Re: Supplemental Report for Hillview Drive Slope Repair
Vista Tassajara, Danville, California
SFB Project No.: 768-1

In accordance with the request of the Vista Tassajara Homeowners Association, Stevens, Ferrone & Bailey Engineering Company, Inc. (SFB) has prepared this supplemental report in order to respond to review comments prepared by Cal Engineering & Geology (CEG) in their letter addressed to the Town of Danville, dated June 29, 2017. Previously, SFB prepared a geotechnical engineering report dated June 5, 2017 and also prepared hillside repair plans dated June 2017. Our responses to the CEG comments are listed below in accordance with the numbering system used by CEG in their letter. The information, opinions, conclusions, and recommendations presented below are meant to supplement our previous report dated June 5, 2017; all previous recommendations, conditions, and limitations apply.

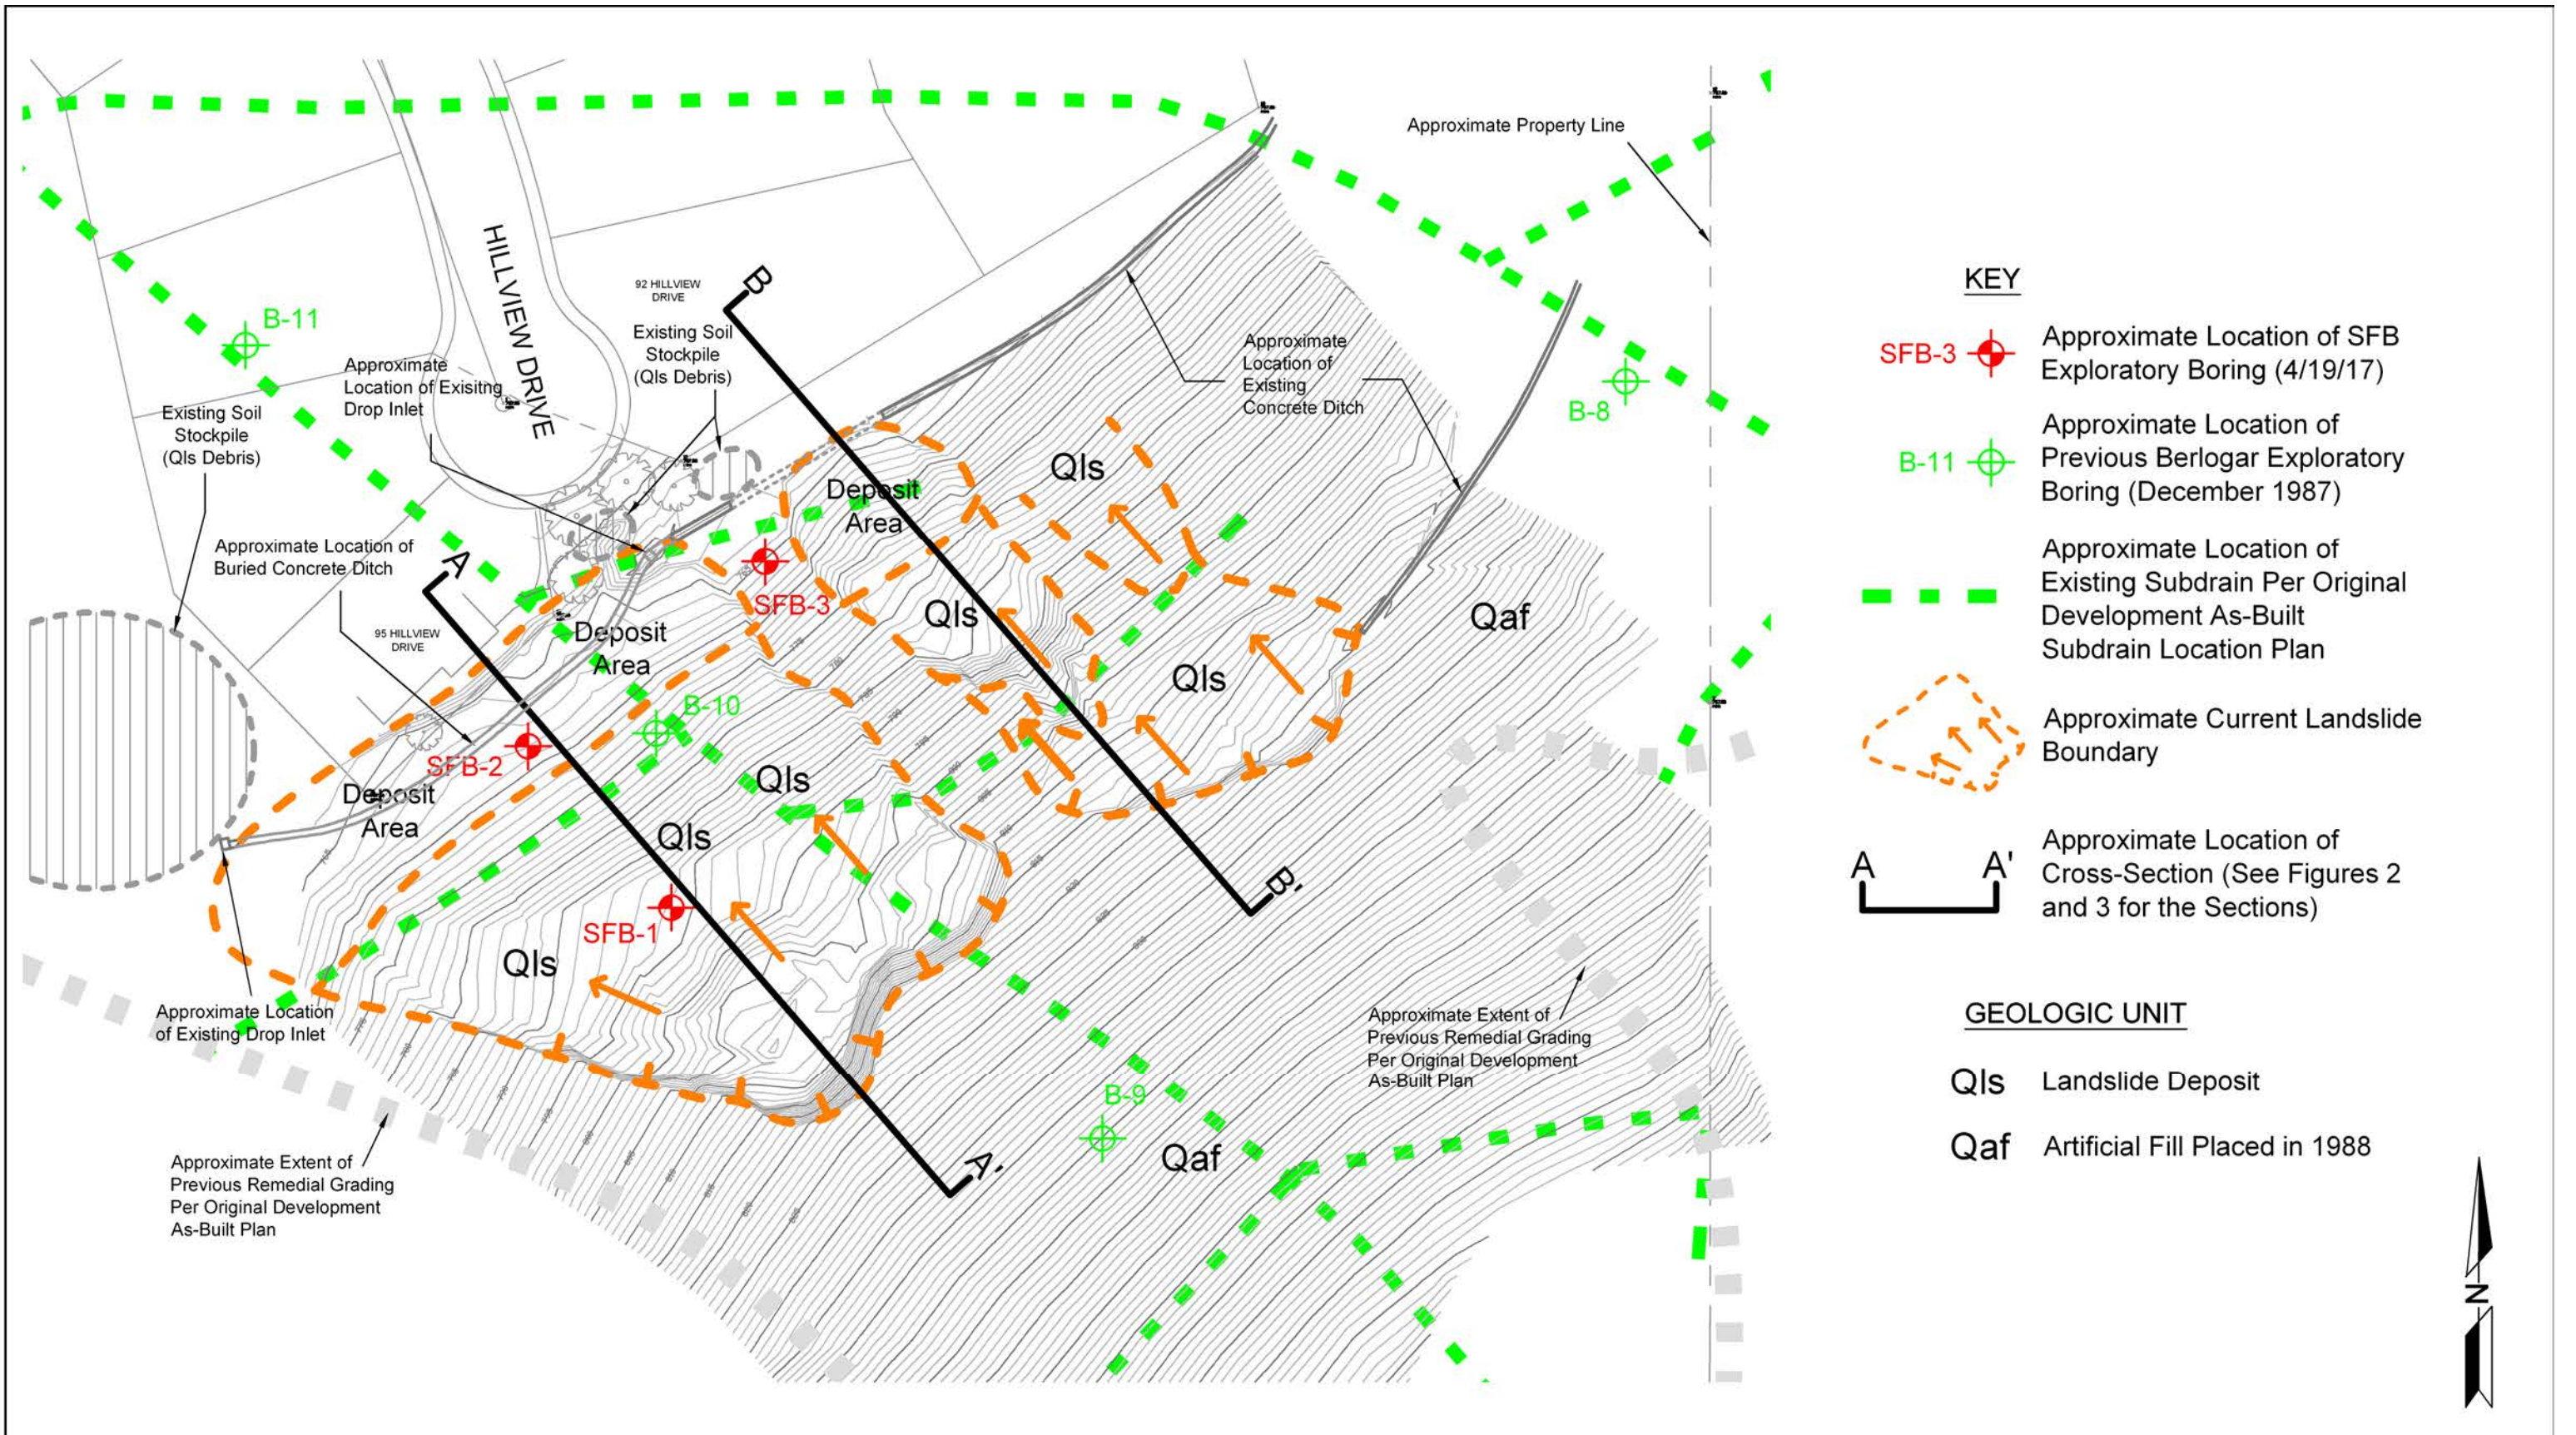
CEG Comment 3 Response: The 1988 subdrains are shown on the attached Figure 1 (Site Plan) and the attached Figures 2 and 3 (Cross-Sections). The 1988 as-built subdrain plan only shows the approximate plan view of the subdrains and does not show at what elevations the subdrains are located. Based on our understanding of the Berlogar Geotechnical Consultants (BGC) report for the 1988 grading project, the subdrains were to be placed at the bottom of over-excavations and keyways. In the area of the Hillview Drive landslide repair project, the 1988 subdrains therefore should be located at the interface between bedrock and the 1988 fill materials. Our interpreted depths (based on BGC reports) of over-excavation performed in 1988 are shown on our cross-sections in our previous report and on Sheet 5 of the plans. We don't anticipate encountering any of the 1988 subdrains since the current landslide has occurred within the existing fill materials as shown on our cross-sections. If any of the 1988 subdrains are encountered, the encountered 1988 subdrains will be properly connected to a drainage system so that they can continue to function. This task will be added to the project plans as a remedial slope grading note on Sheet 1. As shown on Sheet 6 of the plans, the lowermost subdrain is planned to discharge at the existing concrete v-ditch located in the open space area to the west of the landslide repair site (see plan sheet 2 for a view of the v-ditch). The elevation of the lowermost subdrain discharge location is at approximately 730 feet, significantly lower than the planned lowermost keyway/subdrain elevation of 750 feet at the repair site.

SITE PLAN AND ENGINEERING GEOLOGY MAP

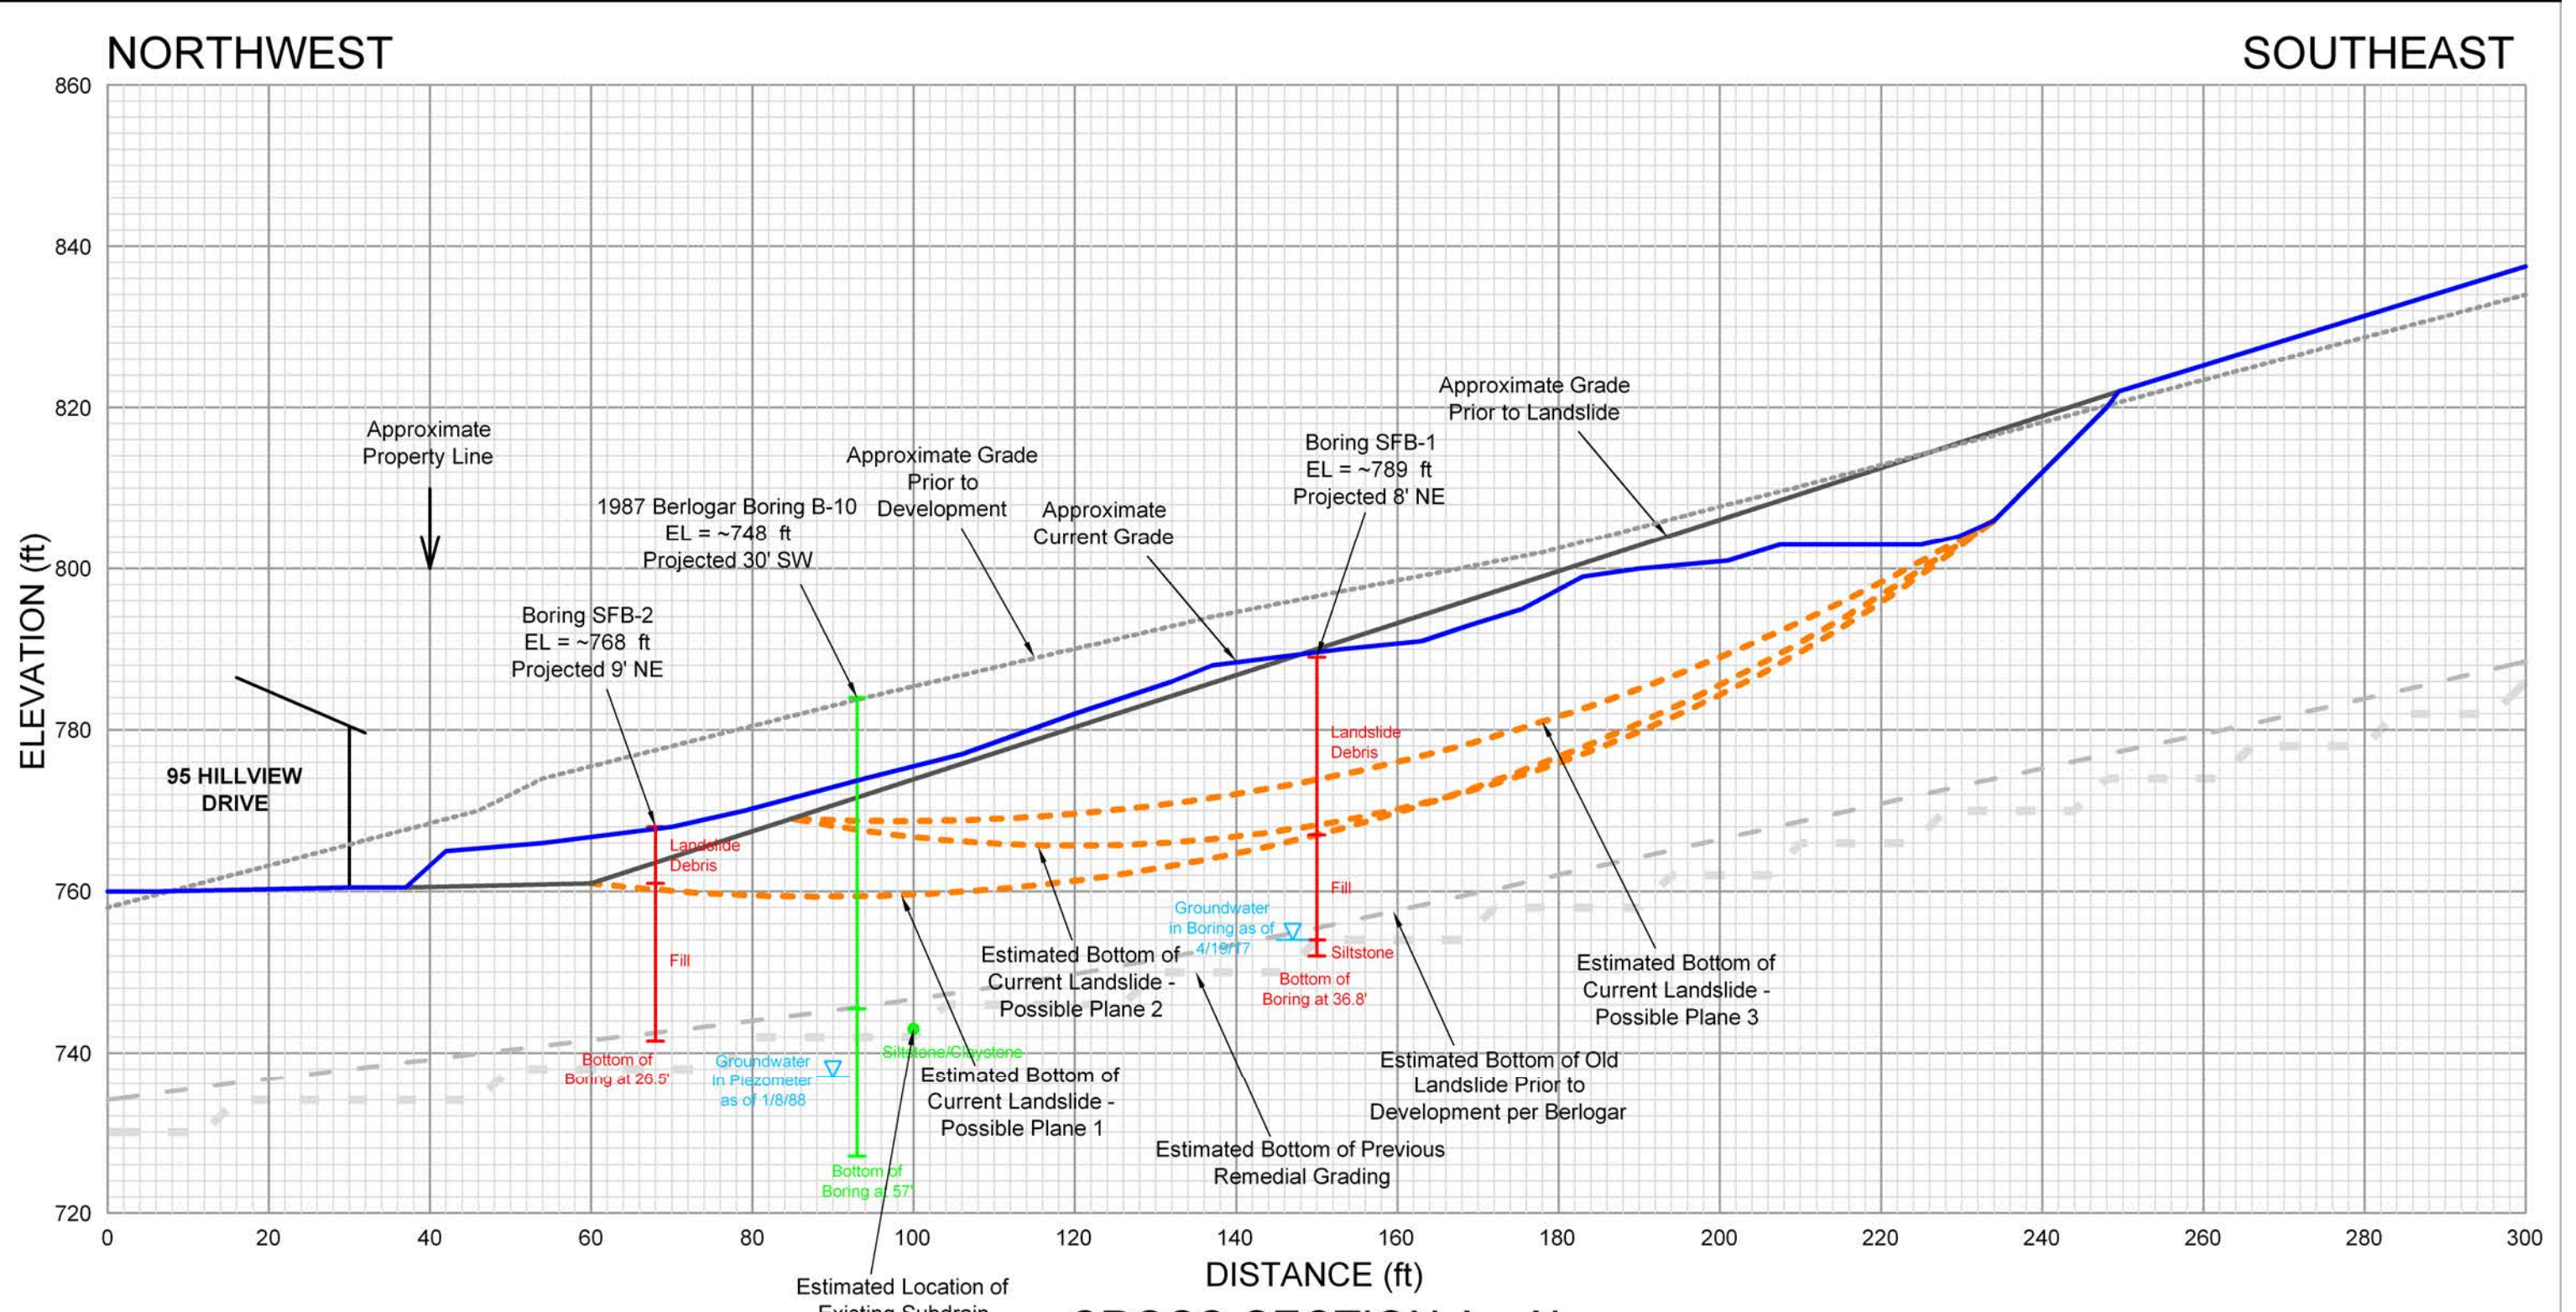
headscarp and toe of each landslide and areas of deposition were located and mapped. Sheet 4 of the plans and Figure 1 of the report shows the results of this mapping. No evidence of ground movement was observed above the headscarp or beyond the toe of the landslides. The highly plastic characteristics of the relatively homogenous clayey fill materials also show that the basal shape is relatively circular in the more critical deeper landslides. Three possible and conservative landslide planes (as shown on Sheet 5 of the plans and on Figures 2 and 3 of the report) were determined by projecting the headscarp shape through the zone of the potentially deepest section of the landslide bottom and downward toward the toe of the landslides, resulting in a relatively circular shape. As described in our previous June 5, 2017 report in Section 4.0, we also performed slope stability back calculations along these three possible landslide planes to estimate the friction angle of the existing hillslope fill materials. In addition, it is our opinion that none of the shear planes intercept the bottom of the over-excavations performed in 1988 (based on our interpretation of the 1988 grading), therefore, the landsliding has occurred wholly within the previously placed fill materials and the underlying bedrock is not a factor in the recent slope instability. **During the construction phase of this project, the existing landslide shear planes will be completely over-excavated to whatever depth is needed to completely remove the shear planes.**
